STATE OF DELAWARE  
**DEPARTMENT OF TRANSPORTATION**  
800 BAY ROAD  
P.O. BOX 778  
DOVER, DELAWARE 19903

Contract No. T201507402.01  
Federal Aid Project No. BHN-N347(03)  
BR 1-714 on N347 Chapman Road over I-95  
New Castle County

Enclosed is Addendum No. 2 for the referenced contract consisting of the following:

ADDENDA / REVISIONS		<b>NOT TO SCALE</b>	<b>BR 1-714 ON CHAPMAN ROAD OVER I-95</b>	CONTRACT	BRIDGE NO.	<b>ADDENDA AND REVISIONS</b>	SECTION
				T201507402	<b>1-714 /1-714A</b>		AEC
				COUNTY	DESIGNED BY: T. SINGLE		SHEET NO.
				NEW CASTLE	CHECKED BY: D. SEMPLE		3

**MEDIAN MOMENT SLAB -  
PLAN AND SECTION**

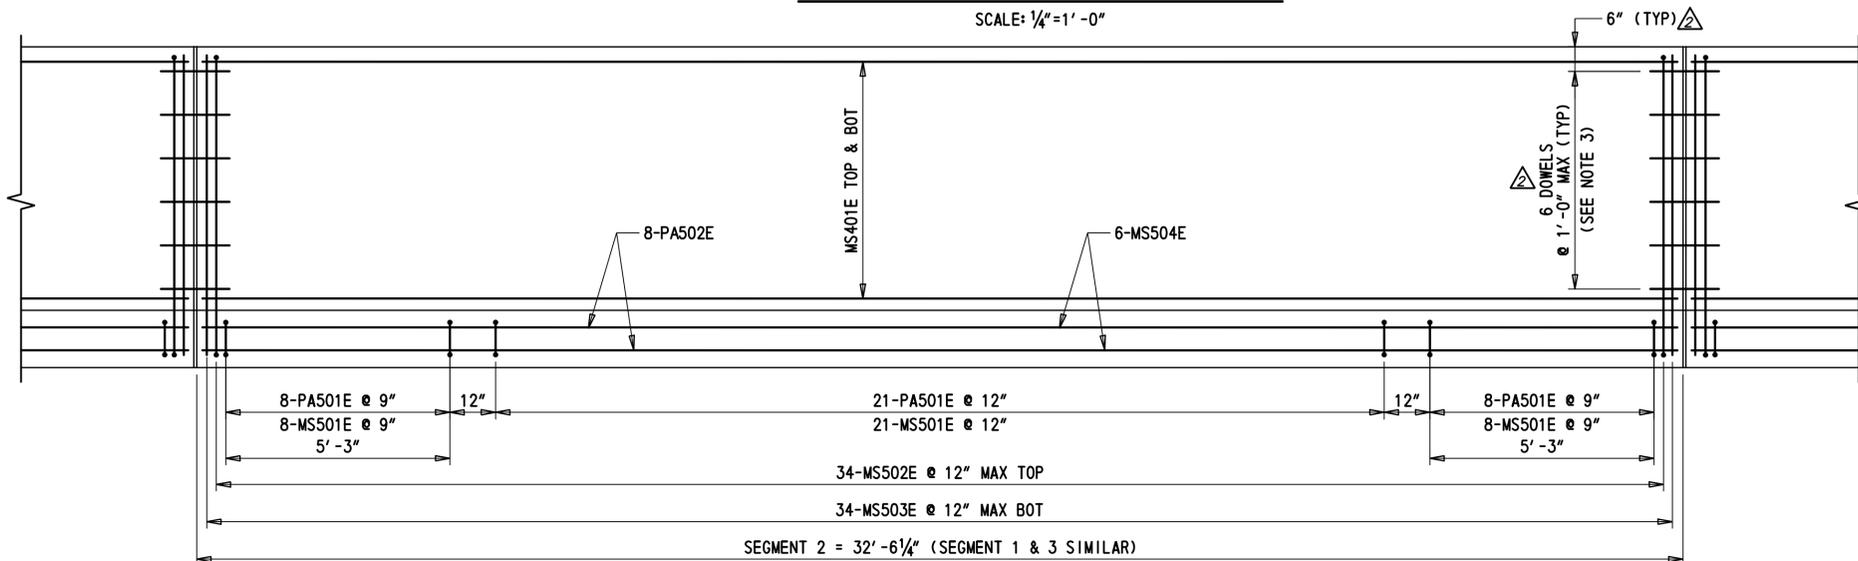
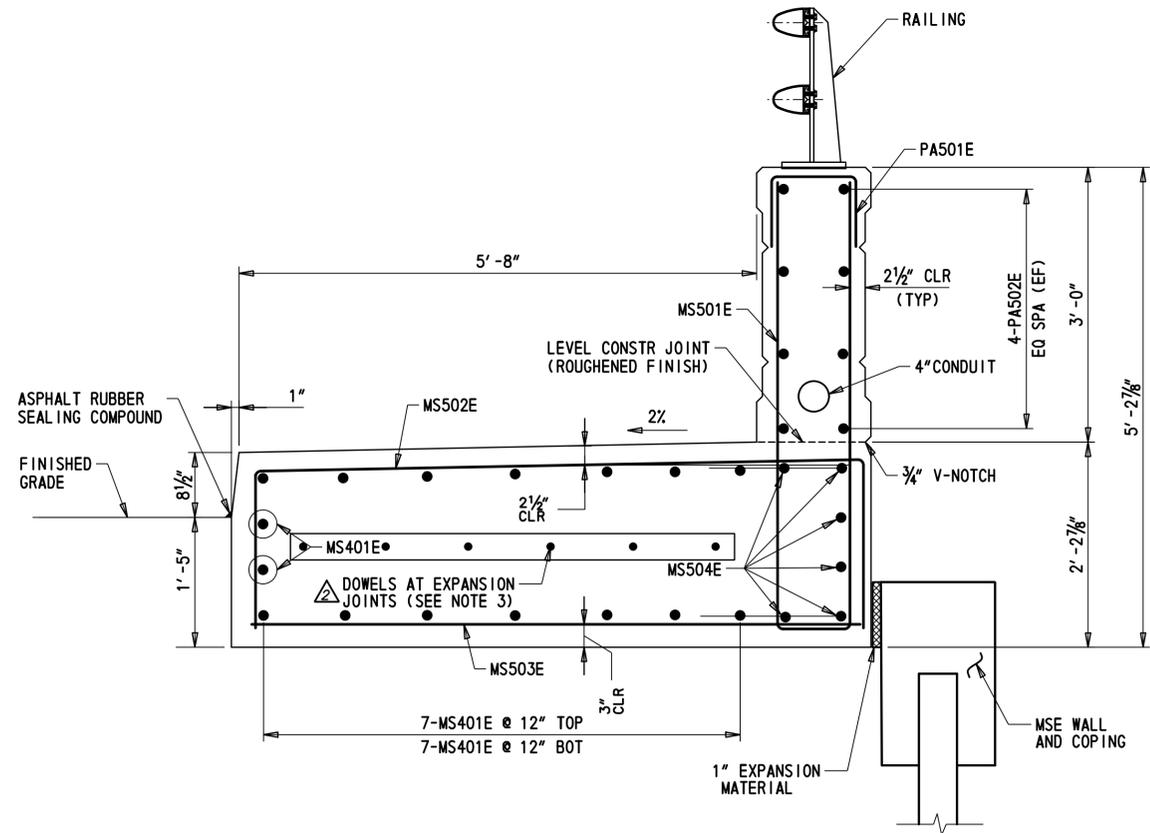
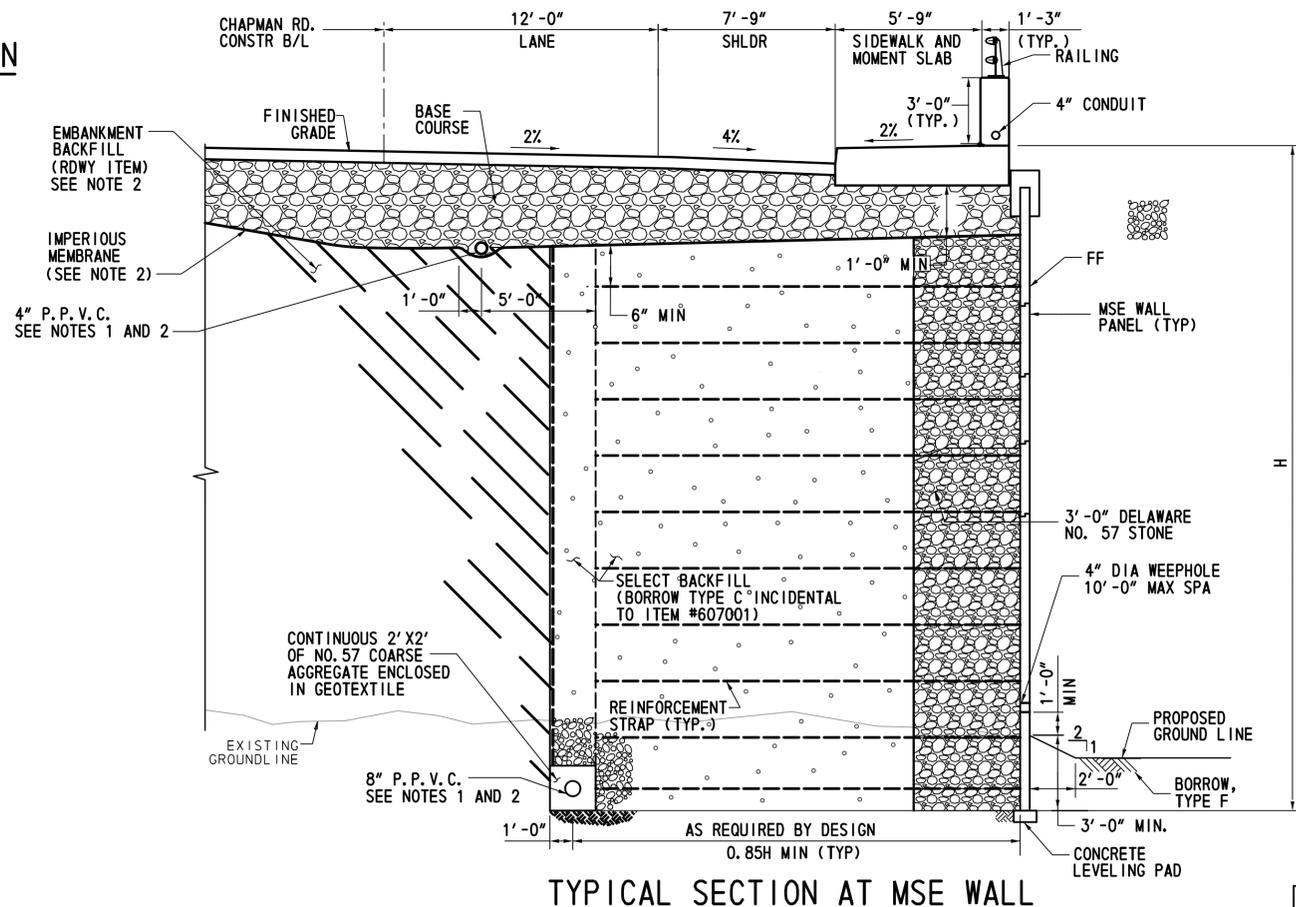
ITEM NUMBER AND DOWEL CLARIFICATION	ADDENDA / REVISIONS
	J. EBERLE 10/16/2019

1. DRAIN PERFORATED POLYVINYL CHLORIDE PIPE (P.P.V.C) TO DAYLIGHT.
2. COST OF IMPERVIOUS MEMBRANE, 4" P.P.V.C. AND 8" P.P.V.C. INCIDENTAL TO ITEM 607001.
3. PROVIDE EPOXY COATED SMOOTH DOWEL BARS 1 1/2" X 18" (MINIMUM). COST OF DOWEL BARS INCIDENTAL TO ITEM 610018.
4. MOMENT SLAB CONCRETE TO BE PAID FOR UNDER ITEM 610018. PARAPET CONCRETE TO BE PAID FOR UNDER ITEM 610008. REINFORCING IN MOMENT SLAB AND PARAPET TO BE PAID UNDER ITEM 611001.
